The Sizewell C Project

6.16 Ch Second Environmental Statement Addendum
Volume 1: Second Environmental Statement Addendum
Chapters

Chapter 2: Main Development Site

July 2021

Plate 2.1: Proposed change to the alignment of Bridleway 19 south of the new B1122/ Lover’s Lane junction

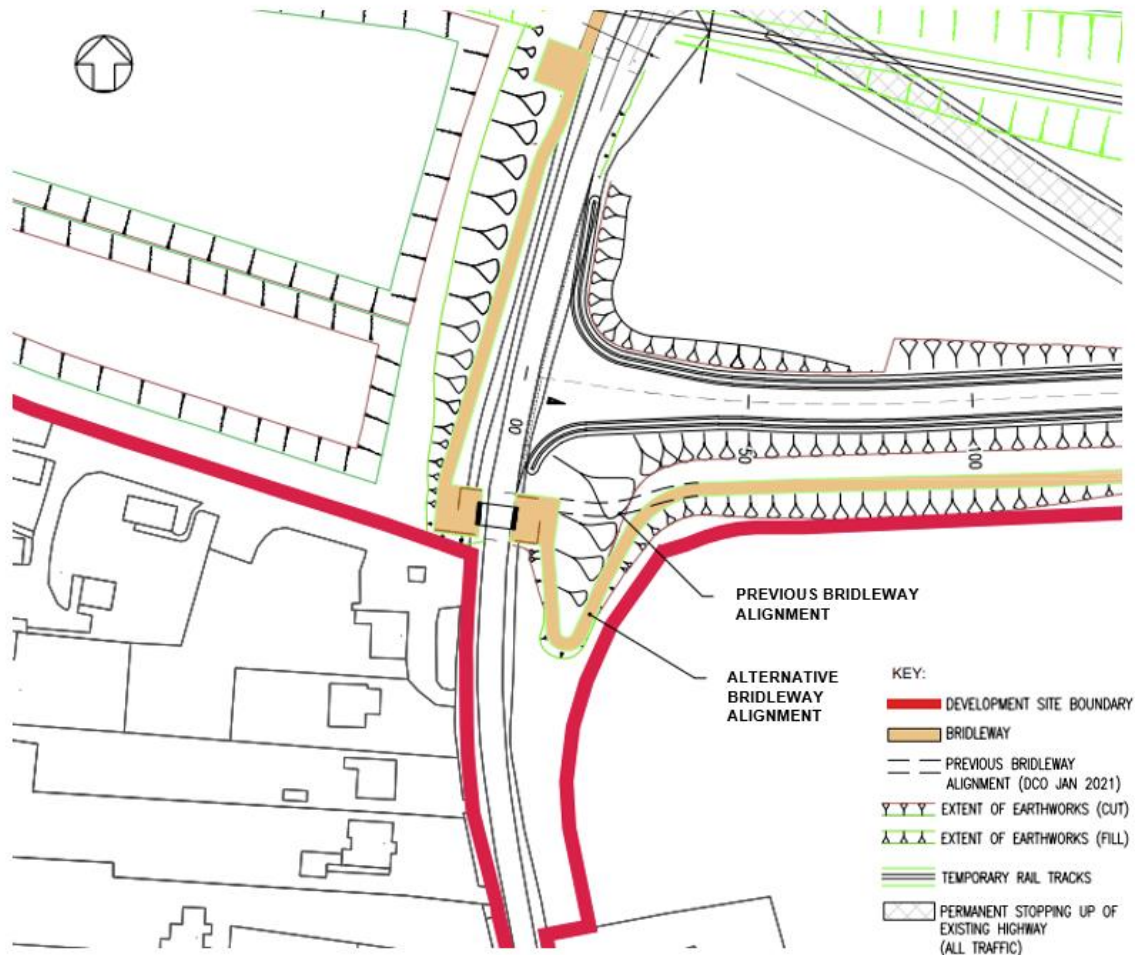
- ii. Description of the proposed change
- 2.2.4 SZC Co. proposes to change the alignment of Bridleway 19 south of the B1122 (Abbey Road) / Lover’s Lane junction from a straight east-west alignment to divert to the south with a kink in the alignment, as shown in **Plate 2.1**. This minor diversion to the south would allow for a less steep gradient for equestrian use. The revised alignment is also shown on **Figures 2.2.2** and **2.2.3** in **Volume 2** of this **Second ES Addendum**.

2.2.8 The change to the alignment of Bridleway 19, south of the B1122 (Abbey Road)/ Lover’s Lane junction would allow for a less steep gradient for equestrian use.

Plate 2.2 Proposed change to the Pegasus crossing and mammal culvert

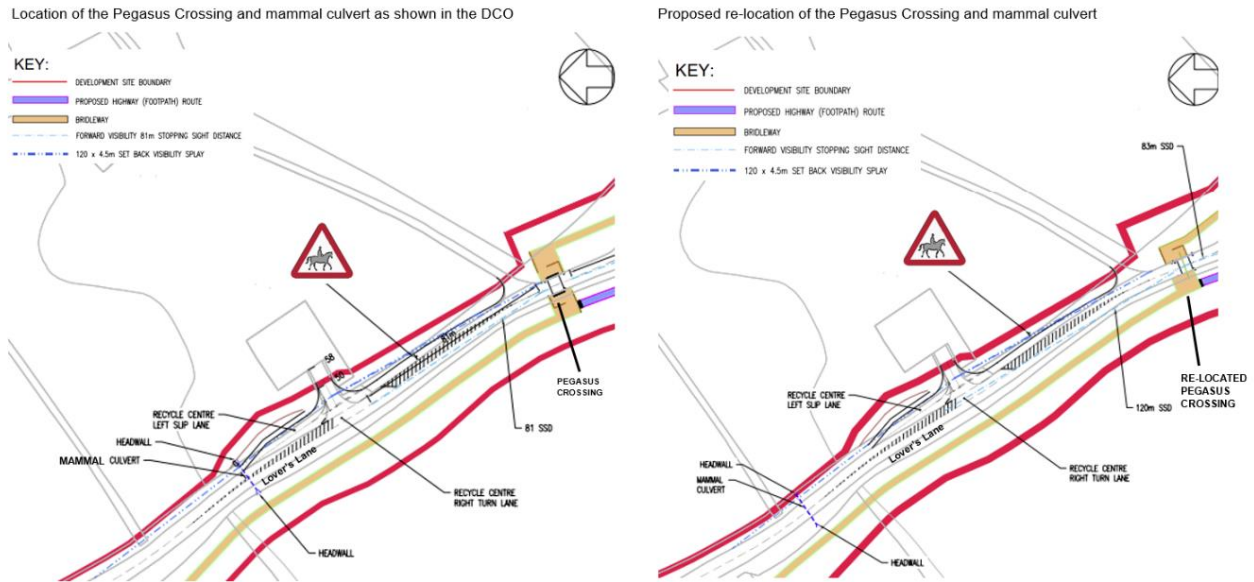
2.2.5 SZC Co. also proposes to relocate the Pegasus crossing on Lover’s Lane approximately 10m to the south (refer to **Plate 2.2**). This would improve visibility for users of the Pegasus crossing and vehicular traffic on Lover’s Lane, including vehicles exiting the existing Recycling Centre in a southerly direction. It would also maintain appropriate visibility splays in compliance with DMRB standards and Bridleway Design Guidelines (Ref. 1).

2.2.9 The relocation of the Pegasus crossing would improve visibility for both users of the Pegasus crossing and vehicular traffic on Lover’s Lane, including vehicles exiting the existing Recycling Centre in a southerly direction.

2.2.18 SZC Co. proposes to reposition the mammal culvert to be in closer proximity to the Leiston Drain watercourse. As for the proposals described in the Application, the culvert would be designed with features to encourage use by mammals. Otter fencing would also be provided to guide mammals to the crossing.

2.2.21 The re-positioned culvert would make the crossing more attractive and effective for mammals to use and fencing is proposed to guide mammals to the crossing. The level of the mammal crossing would take account of the flood modelling in the Leiston Drain area.

Plate 2.3 Proposed Bridleway 19 change at Paines Plantation

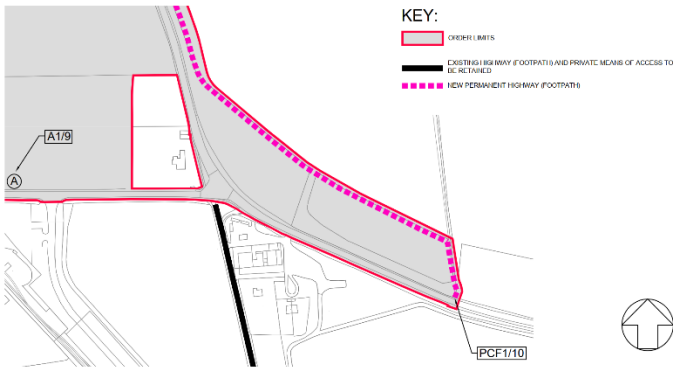
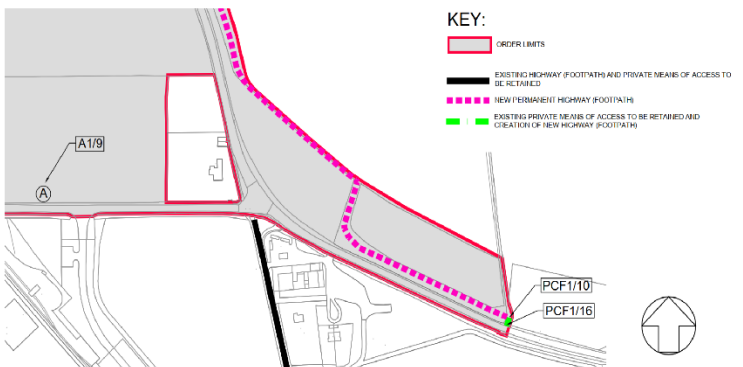
2.2.11 Further design development has identified that, if there was no change proposed, the alignment currently set out in the Application would require the removal of a strip of trees measuring approximately 300m in length and approximately 2m in width, along the northern edge of Paines Plantation to allow the Bridleway to have the necessary width to comply with Bridleway Design Guidelines. This would require the removal of 60-80 trees. The current width of Paines Plantation varies, but the majority is between 40–60m wide.

2.2.12 SZC Co. now proposes to change the alignment of Bridleway 19 to pass along the south of Paines Plantation, and then pass through an existing gap in the woodland of Paines Plantation, before continuing along the northern edge of Paines Plantation (**Plate 2.3**).

2.2.13 This change will minimise tree loss, as Bridleway 19 will only pass along the northern edge of Paines Plantation, where the existing trees are located, for approximately 150m (see **Figures 2.2.4** and **2.2.5** provided in **Volume 2** of this **Second ES Addendum**). This would result in the removal of 30-40 trees.

- 2.2.15 The change is proposed so that Bridleway 19 can pass between the tree belt and the site boundary with the necessary width to comply with Bridleway Design Guidelines, whilst also minimising tree loss.
